Product change notification (PCN)

Title / short description	New equipment
Affected article category	Electronic housing
Change category	Form and appearance
Change number	PAC190023-04

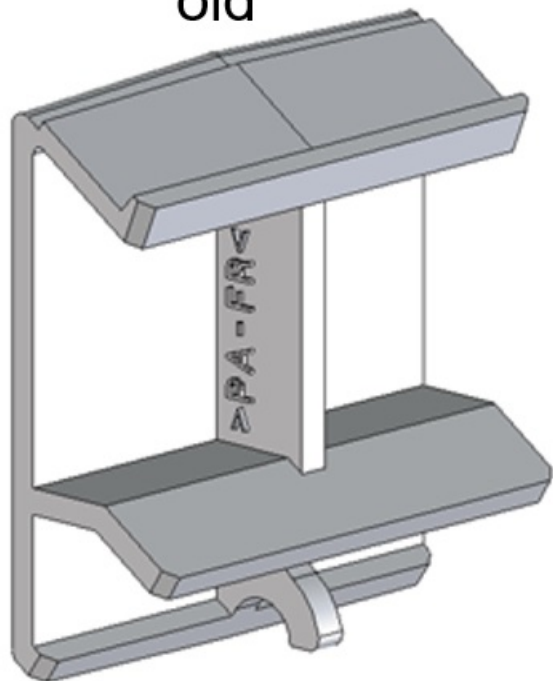
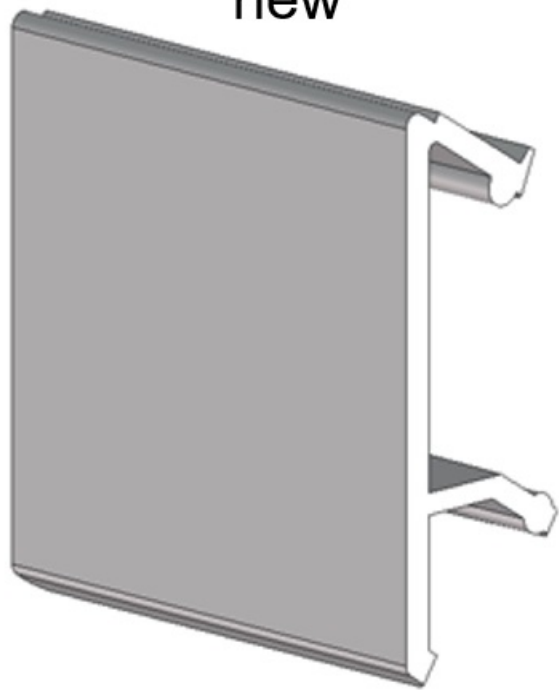
Update concerning the initial discontinuation information released on 2020-08-19. The detailed description of the previous version has been updated. The previous plastic tool has reached the end of its service life and must be replaced with a new tool. As part of this, a product improvement will be introduced in the form of optimized radii. In addition, the text applied will change from "PA-FR" to "PA". This does not affect the component's function.
